APPLICATION NUMBER: RECON 25/0058

PROPOSAL: RECONSTRUCTION OF A FIRE DAMAGED PORTAL FRAMED BUILDING

SITE: Unit 3A to 3B Nash Mead Newport NP19 4SU

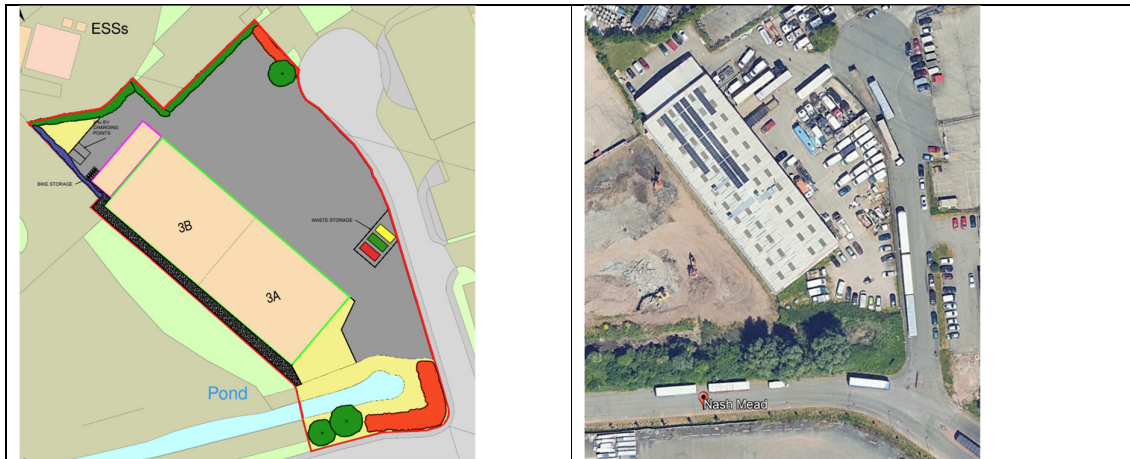
Planting proposals are now shown on the Proposed Site Plan by Steven Morgan Associates, refer extract below. This would meet LDP GP5 for an appropriate landscape scheme.

1. The planting schedule shows plants for H1, H2 and H3 but the locations are not shown on the plan and there is no obvious translation (H2 has four times the planting numbers of the others).
2. I am not clear whether hedge planting to the south-east corner at the road junction would affect the visibility splay and suggest a referral to highways. There appears to be sufficient room to accommodate a hedge outside any agreed splay.

Existing trees are now shown south of the re-en, so the re-en would act as a tree protection barrier eg to storage of materials etc.
